# COUNTY OF SANTA BARBARA PLANNING AND DEVELOPMENT

## MEMORANDUM

**RE:** Continued Babbit et al. Appeals of Scibird Exterior Alterations  
Case Nos. 23APL-00031 & 23APL-00033 [21LUP-00000-00292 & 22BAR-00000-00187]

Abate Planning & Building violations and remodel house, convert garage / workshop into an ADU for:  
**Scibird / McGonegle**  
 539 Periwinkle Lane, Montecito CA 93108

### Proposed Roof Plan

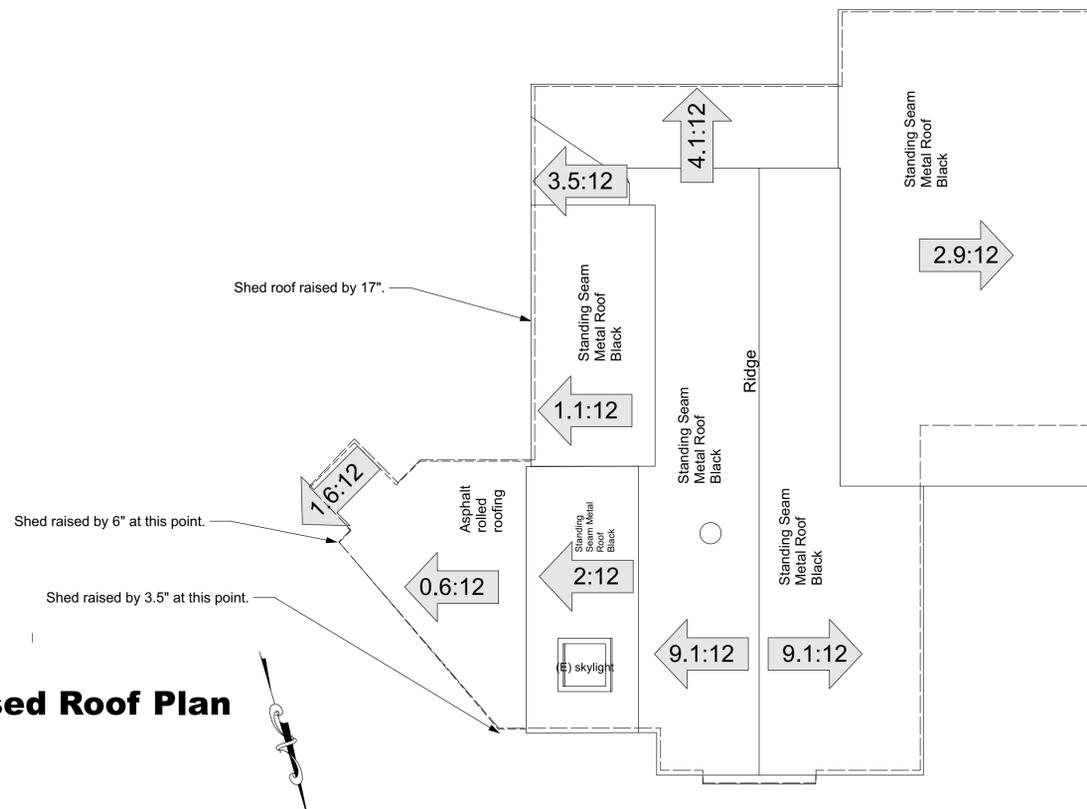
- Since the February 21, 2024 MPC hearing date, the roof material is now proposed to be black metal standing seam, as is existing and permitted by Building Permit No. 20CNP-00000-00784. This change is reflected in the updated plans dated March 4, 2024, included as Attachment A to this memorandum.
